## Technical Note 01: Watlington Relief Road (WRR): Transport Comment

**Project:** Watlington Relief Road  
**Subject:** Comment on Environmental Statement  
**Client:** Shirburn Parish Council and The Beechwood Estates Company Limited  
**Prepared by:** Bruce Bamber **Date:** March 2024

**Figure 1: Google Maps Recommended Routes between Didcot and High Wycombe**

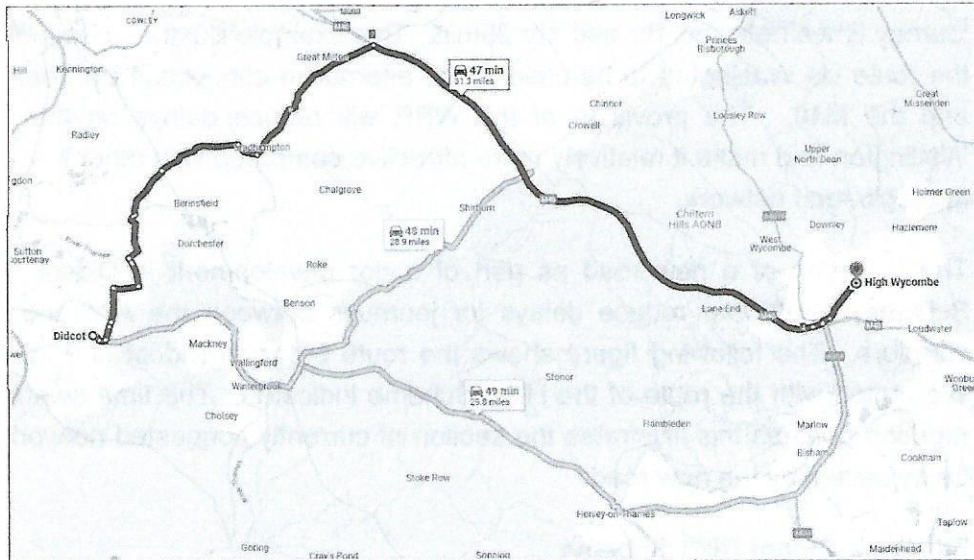
45. It can be seen that the preferred route is via Stadhampton and Junction 7 of the M40 with a time of 47 minutes. The route via Watlington is identified as an alternative but is slightly slower with a time of 48 minutes. The provision of the WRR is likely to reduce the time of the route via Watlington to the extent that it becomes the preferred route. This is just one example of many journeys that are likely to re-assign from other routes to the route using the WRR and Junction 6 of the M40.

**Figure 2: Routes between Milton Interchange and High Wycombe (AM Peak)**

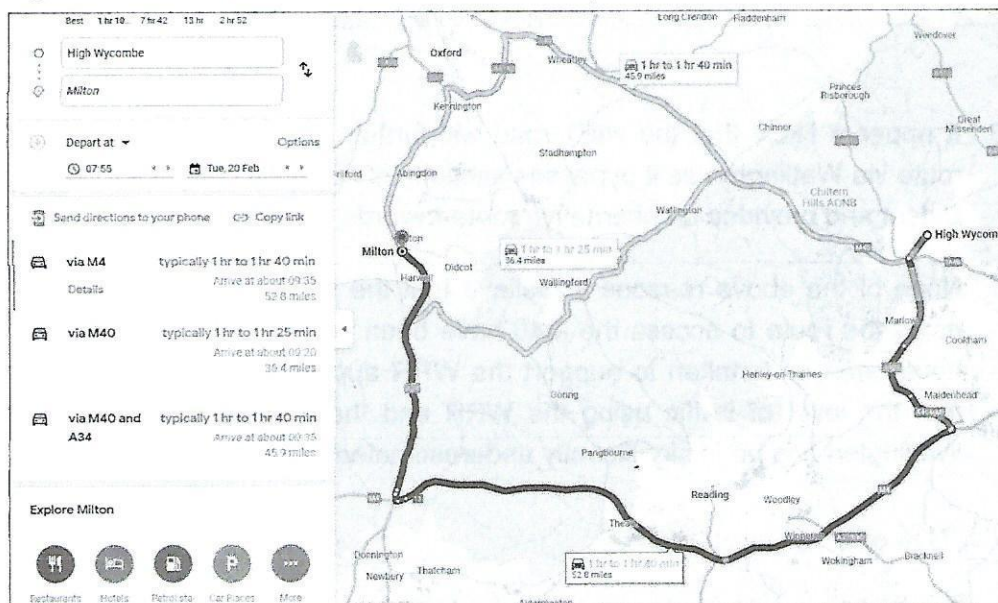
47. The preferred route via the M4 and A404 is shown to be congested with a journey time between 1hr and 1hr 40 min. The route via Oxford Ring Road is shown to be

highly congested with the same range of journey times. The route via Didcot and Watlington is shown to be much less congested (and therefore more reliable) with journey times between 1hr and 1hr 25min. This example illustrates the potential for the route via Watlington to be used as an alternative connection between the A34 and the M40. The provision of the WRR will reduce delays on the route via Watlington and make it relatively more attractive compared with other routes via the strategic road network.

**Figure 3: Didcot HIF1 Scheme**

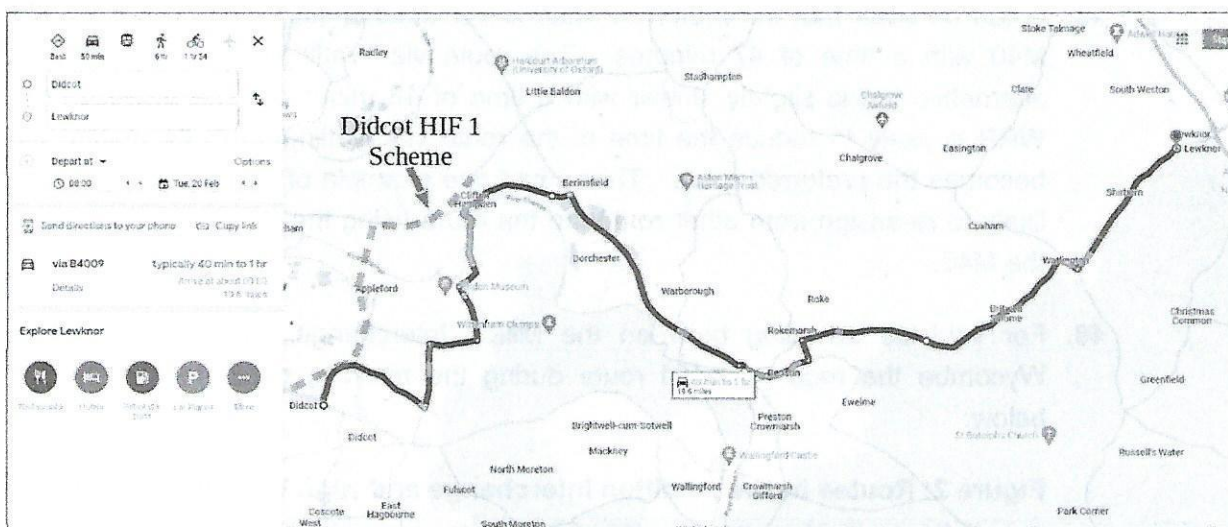
49. It appears likely that the HIF1 road will further increase the attractiveness of the route via Watlington as it bypasses sections of currently congested network north of Didcot and provides an alternative route towards the B4009.
50. None of the above reasons to believe that the WRR will lead to increasing traffic using the route to access the M40 have been considered in the assessments that have been undertaken to support the WRR application. There is therefore a risk that the level of traffic using the WRR and the associated routes either side of Watlington has been significantly underestimated.
